**Moorhead Area Public Schools
New Elementary School
Moorhead, Minnesota**

Project No. 15-025

ADDENDUM No. 1

1 AREA D ENLARGED PLAN
SCALE: 1/8" = 1'-0"

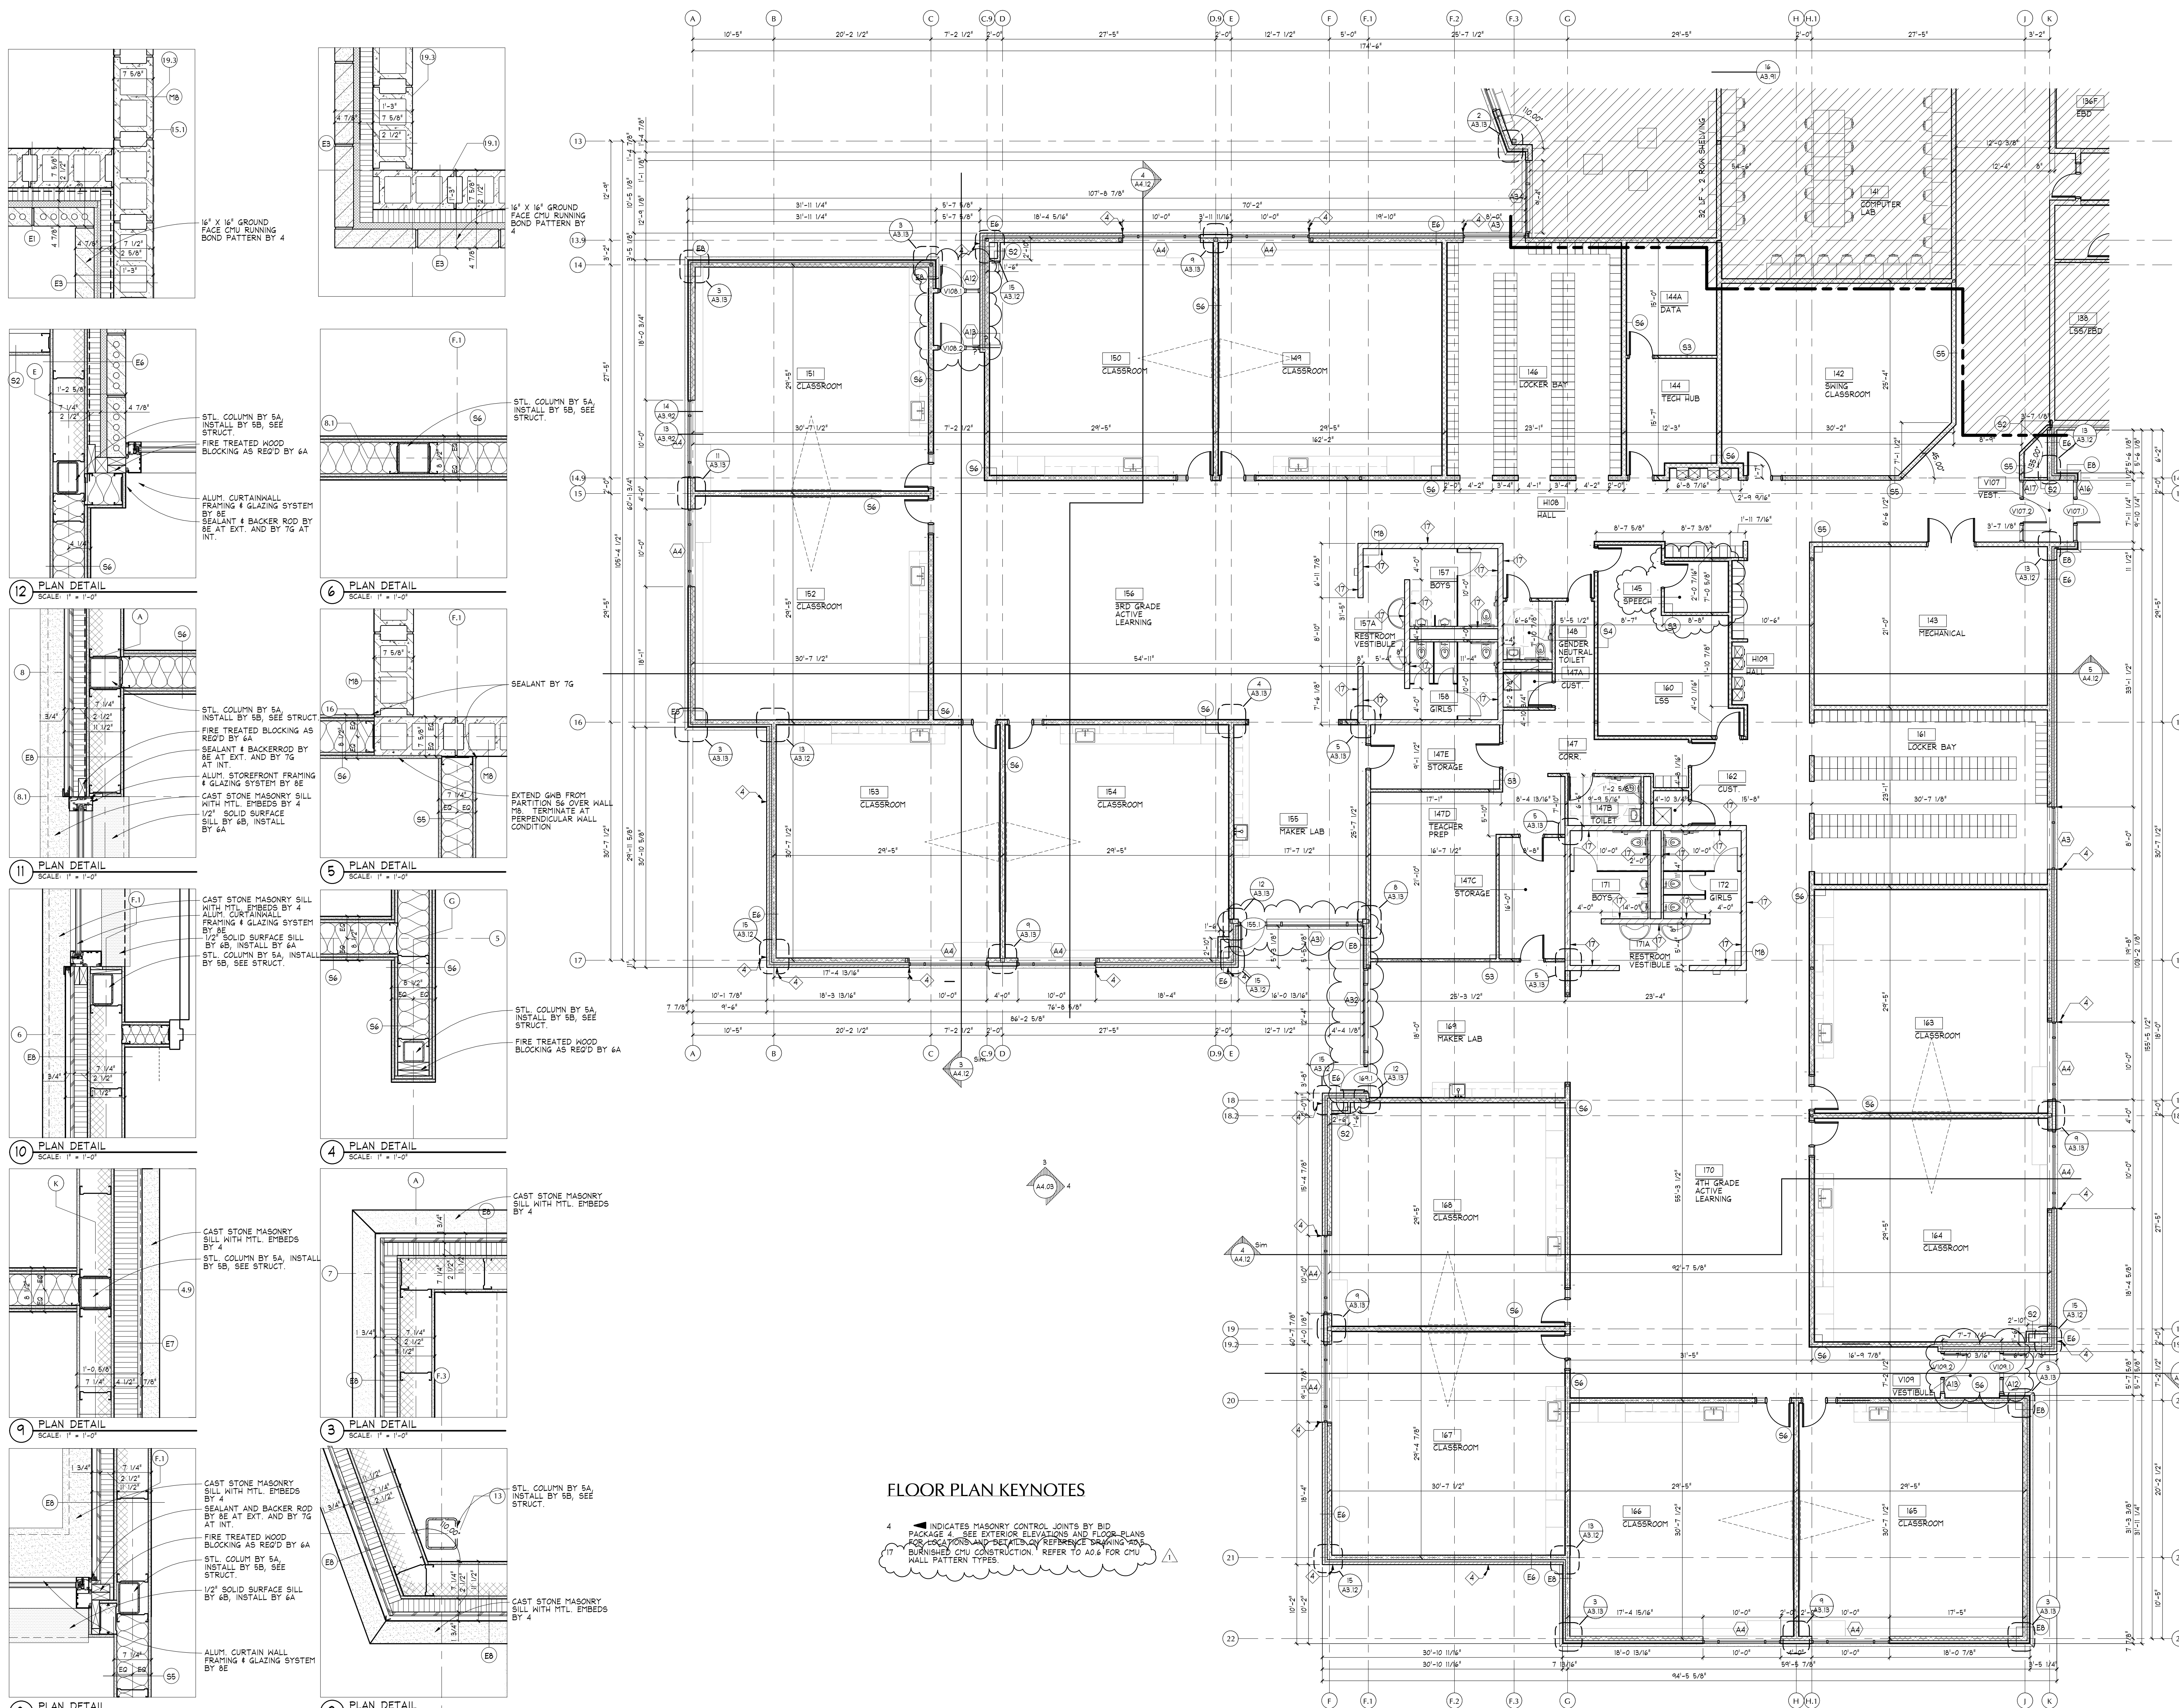
1. Area D Enlarged Plan:
 - a. See attached revised plan for additional aluminum frame and door tags.
 - b. Revise LSS 145 & LSS 160 as indicated in attached revised plan. LSS 145 shall be renamed to Speech 145.

6 AREA B - EAST ELEVATION
SCALE: 1/8" = 1'-0"

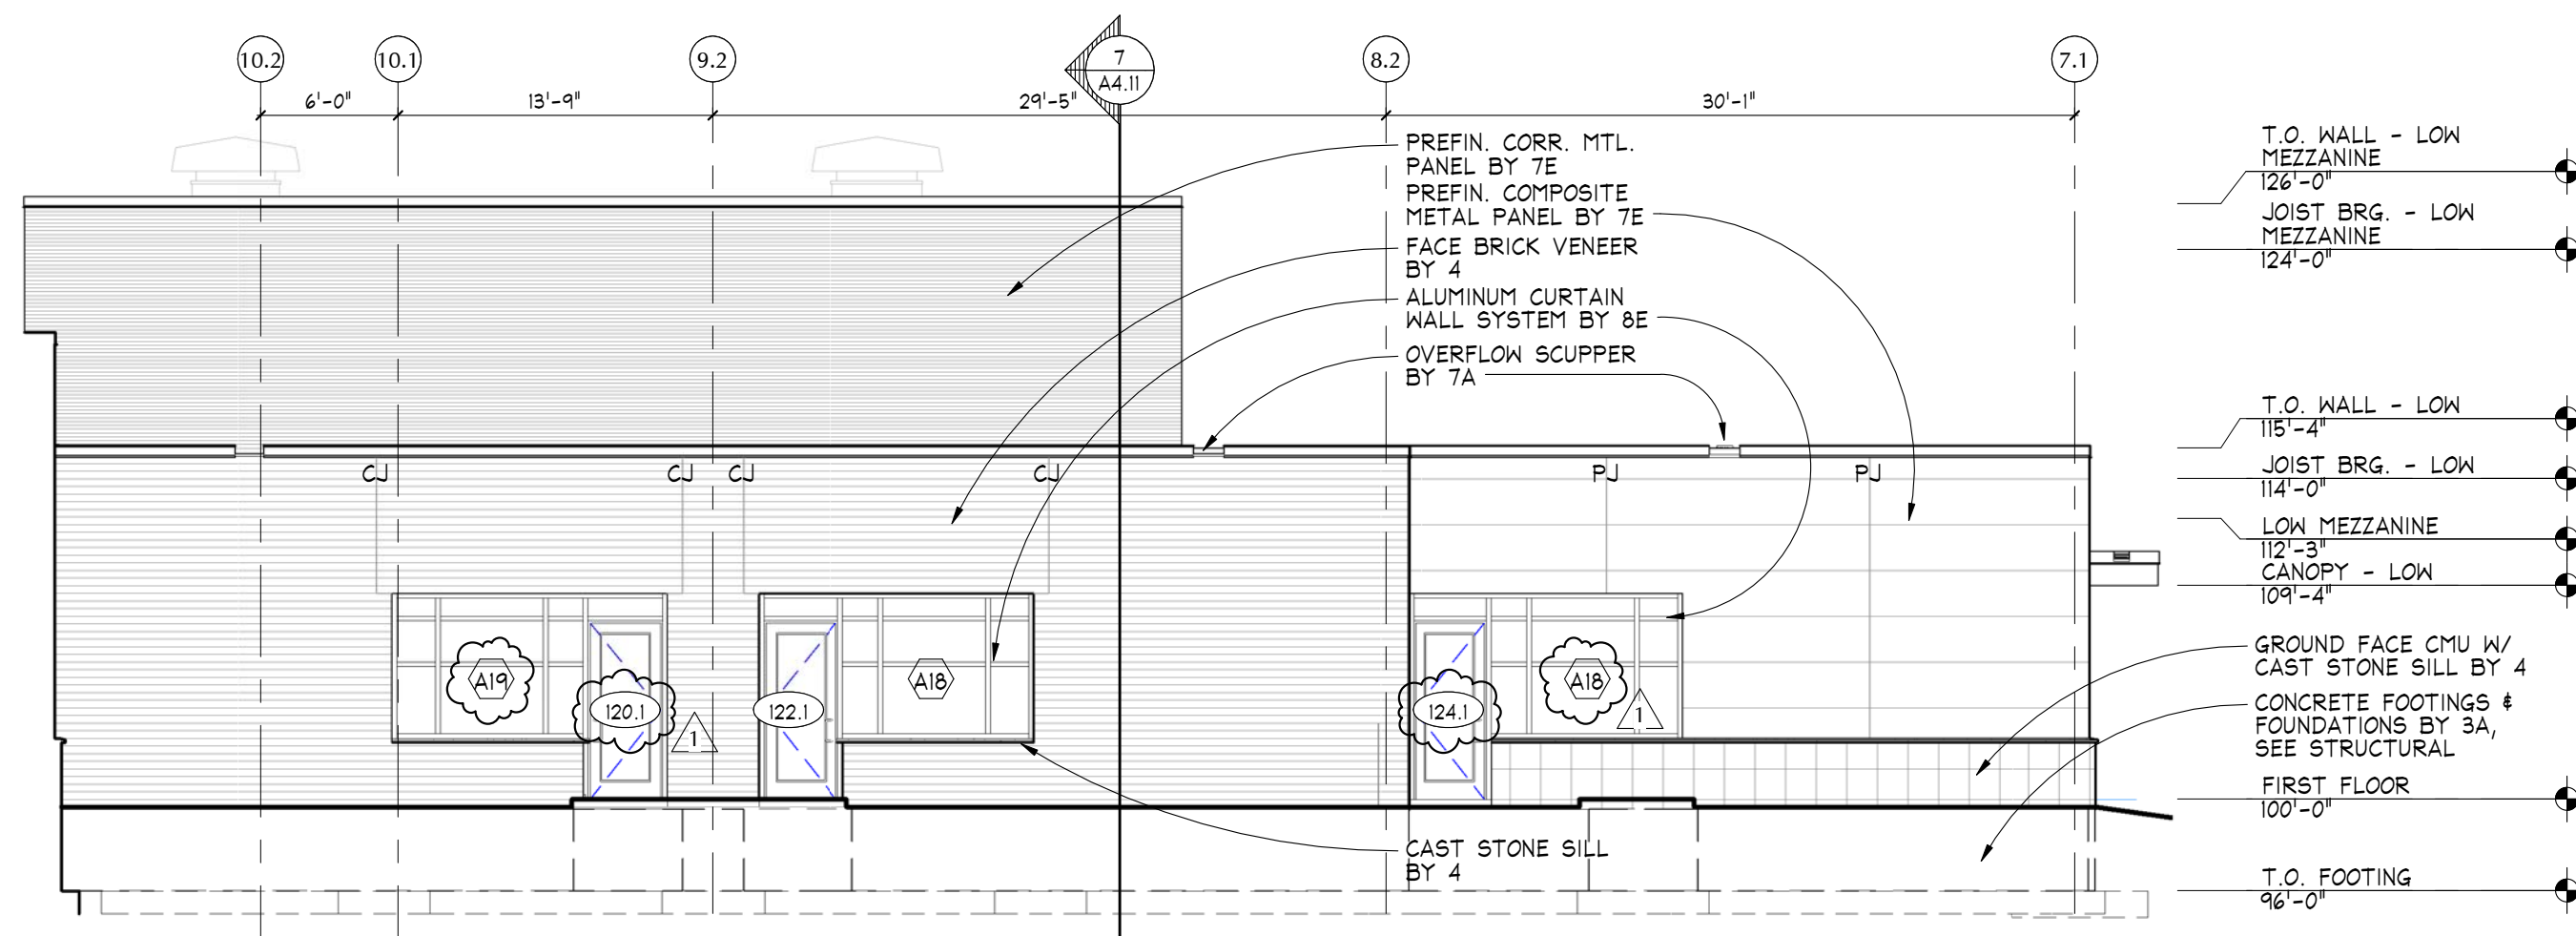
1. Area B – West Elevation, 4/A4.02: See attached revised elevation for additional aluminum frame and door tags.
2. Area B – East Elevation, 6/A4.02: See attached revised elevation for additional aluminum frame and door tags.

2 AREA D - EAST ELEVATION

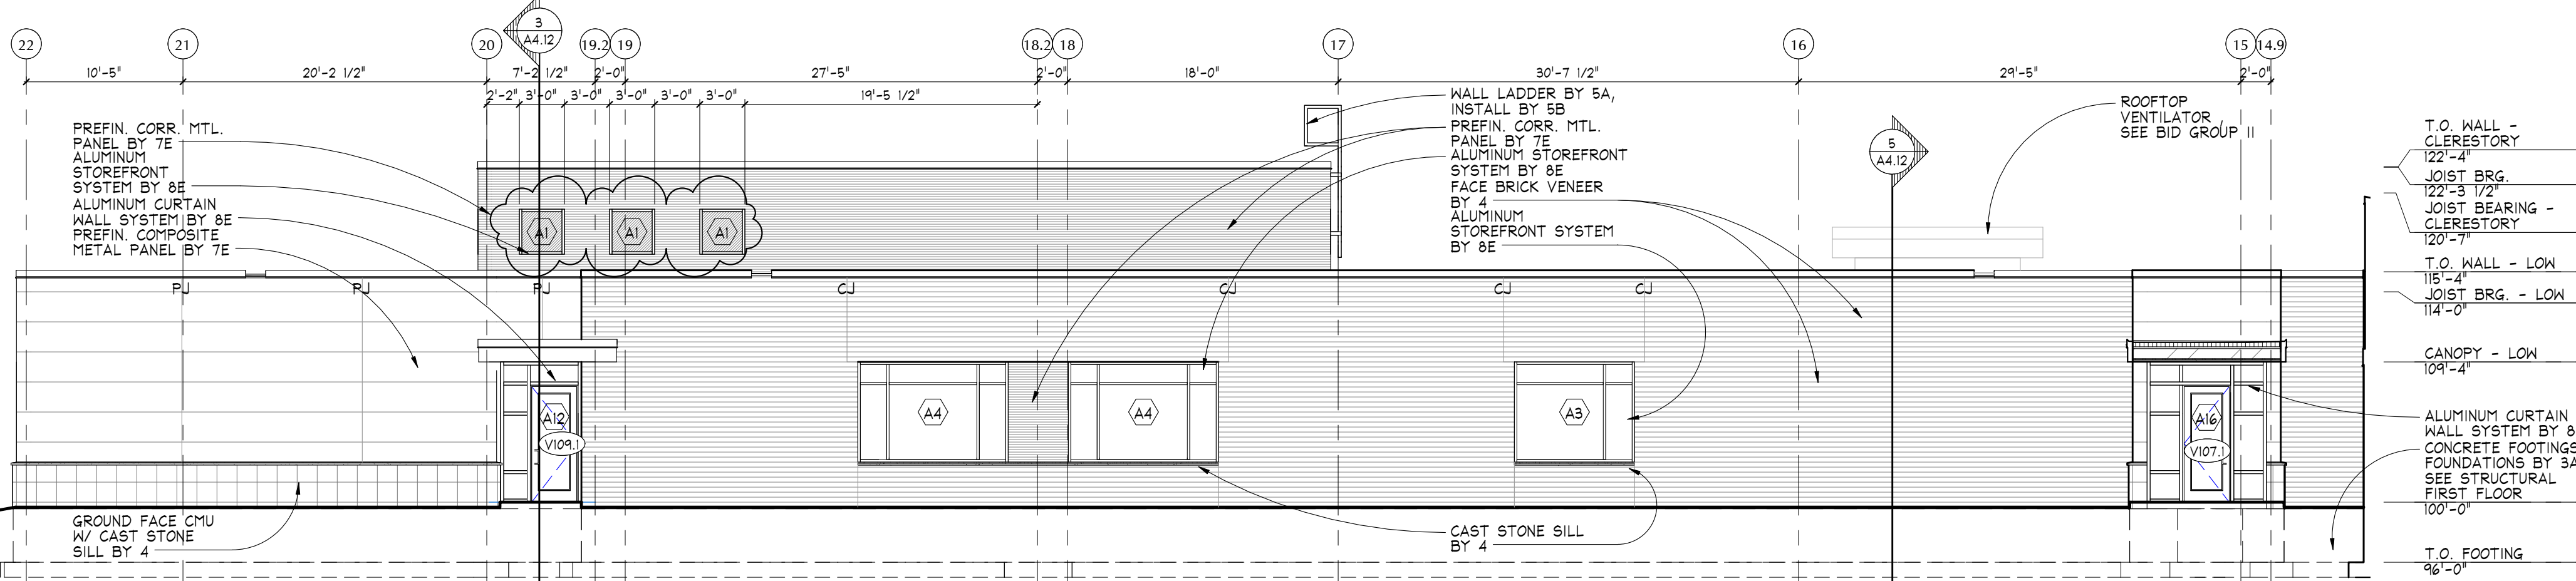
1. Area C – East Elevation, 1/A4.03: See attached revised elevation for additional aluminum frame and door tags.
2. Area D – East Elevation, 2/A4.03: See attached revised elevation for additional aluminum frame and door tags.
3. Area D – South Elevation, 3/A4.03: See attached revised elevation for additional aluminum frame and door tags.
4. Area D – West Elevation, 4/A4.03: See attached revised elevation for additional aluminum frame and door tags.
5. Area D – North Elevation, 5/A4.03: See attached revised elevation for additional aluminum frame and door tags.
